SURVEYOR LUNAR ROVING VEHICLE

Phase I — JPL Contract 950657

VOL. II: APPENDIXES

Section V Additional Information on RTE

**Figure 1.   RTE Raw Power vs Weight : Pb Te Thermoelements**

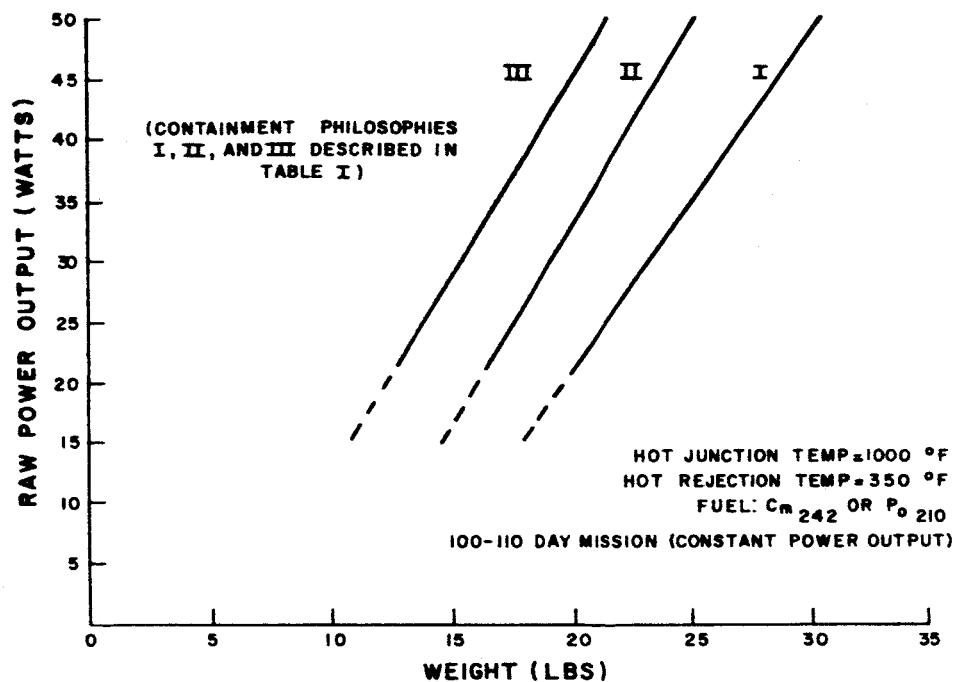
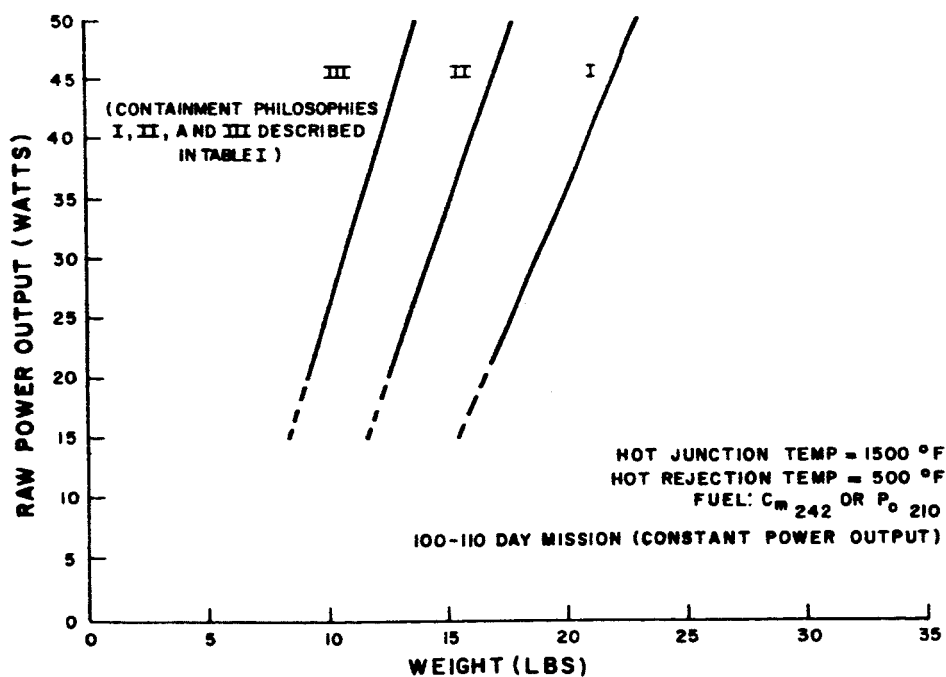
The following information was received after the submission deadline of the Final Report. This information modifies Section II, Electronic Subsystems, Appendix III, Power Supply Subsystem by eliminating Tables II. 3-16 through II. 3-19 and adding the following information. General reference is made to the Power Supply Subsystem Appendix throughout this section.

The recent information received from the Martin-Marietta Corp. changes the RTE weights. The new weights are tabulated in Tables 1 and 2 for lead telluride and silicon-germanium thermocouple types, respectively. The data is also shown graphically in Figures 1 and 2. The requirements set forth for the RTE were the same as those indicated before, but are repeated for convenience:
